Staff Report

Replace existing structure with a new structure with same three dimensional footprint. New swimming pool. This building has been declared unsafe by the Chief Building Official- **#1219 Newton Street Paul Cox (H12-01-1247)**

This staff report is for the review of a Certificate of Appropriateness for a reconstruction on its three dimensional footprint of a contributing house that has been declared unsafe by the Chief Building Official. Copy of the letter declaring the building unsafe is included in the packet for further review. The existing house is listed as a contributing resource. The one story structure was built circa 1890.

FRONT ELEVATION
SCALE - 3/16" = 1'

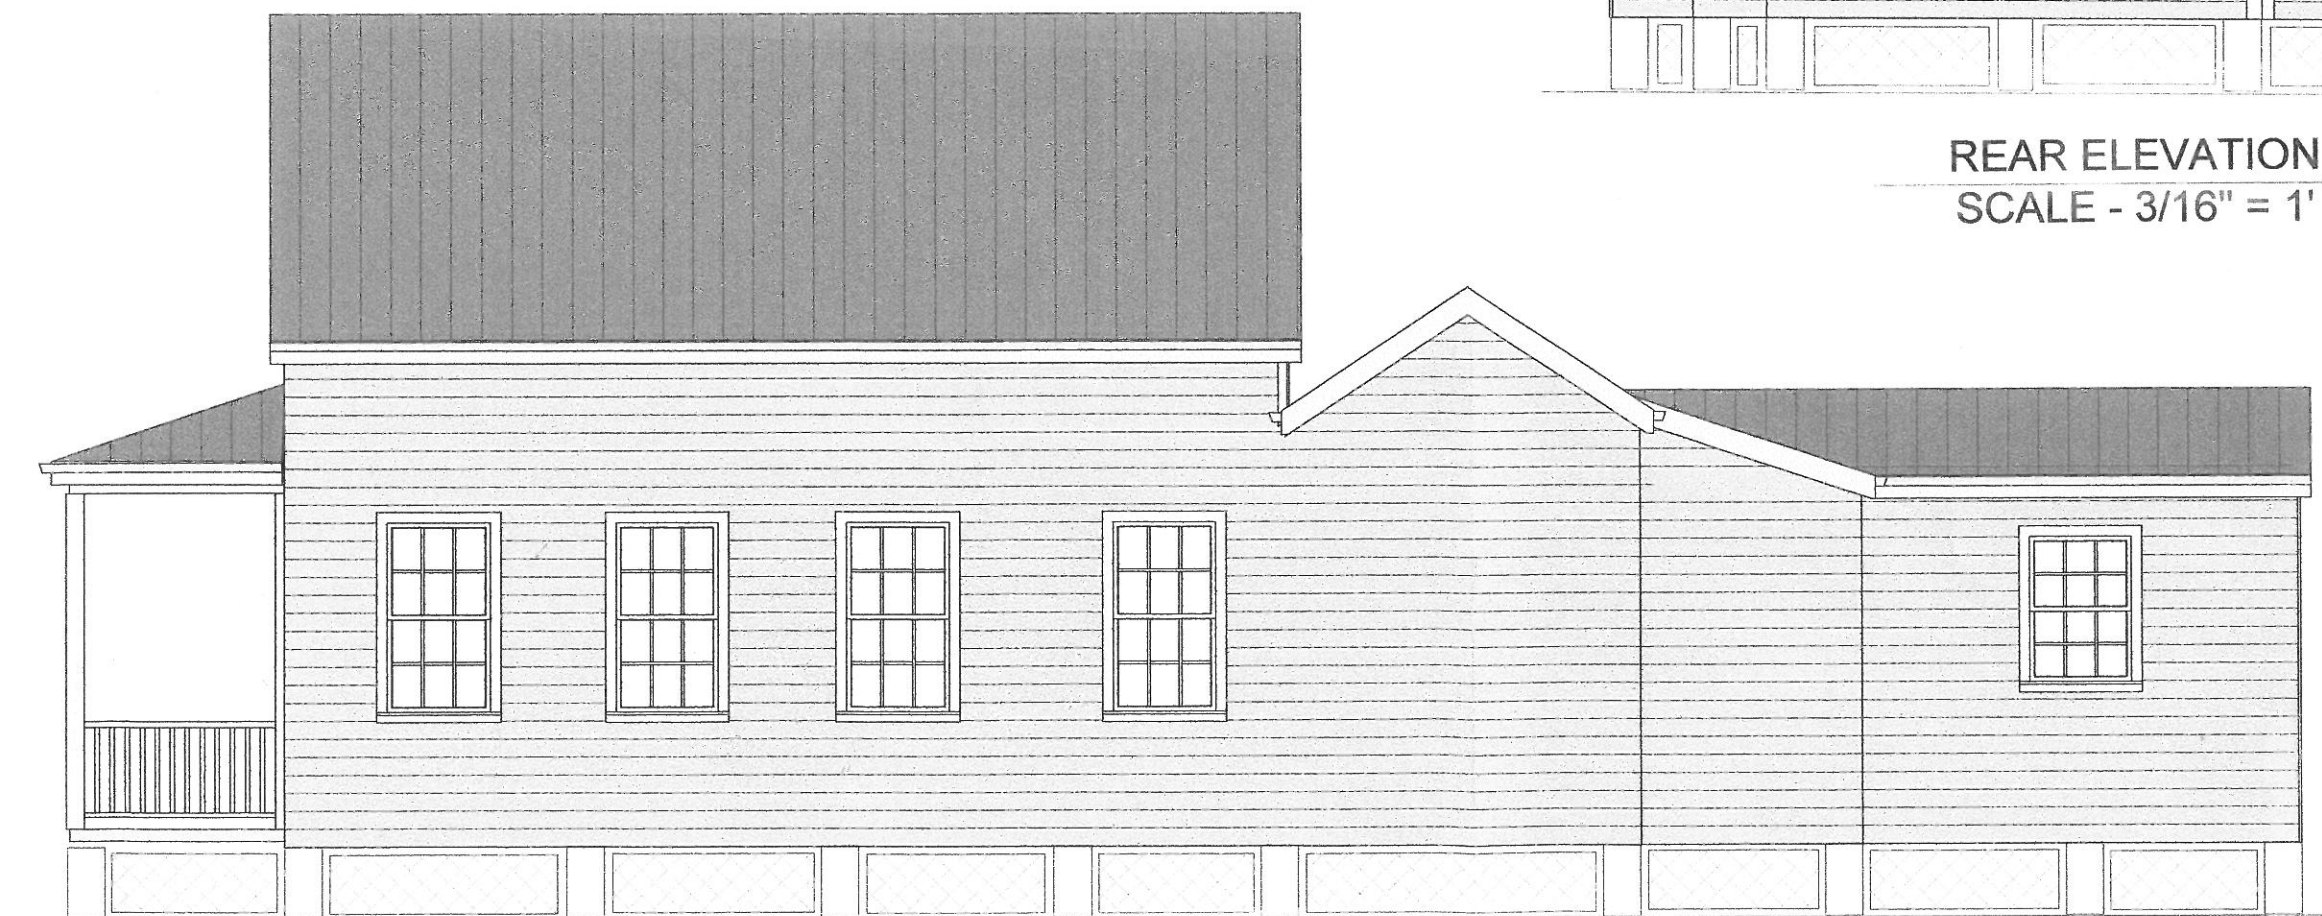
The notes in the plans include 6 over 6 double hung impact resistant vinyl clad windows, lap siding and metal v-crimp as the roofing material. The house has been elevated in order to comply with the AE-6 flood zone.

The proposed design will not exceed one story.

The new design proposes the same scale, mass and proportion of the existing house.

The proposed design mimics the existing structure.

The proposed materials, textures and forms will be similar to the ones found in new construction in the historic district.

It is staff's opinion that the proposed plans, although includes a design that "mimics" the character of the existing house, but not the construction craftsmanship, complies with the Land Development Regulations as to "built in the historic vernacular". It is staff's opinion that if a contributing house has been lost due to neglect a new construction should not mimic what used to be there.
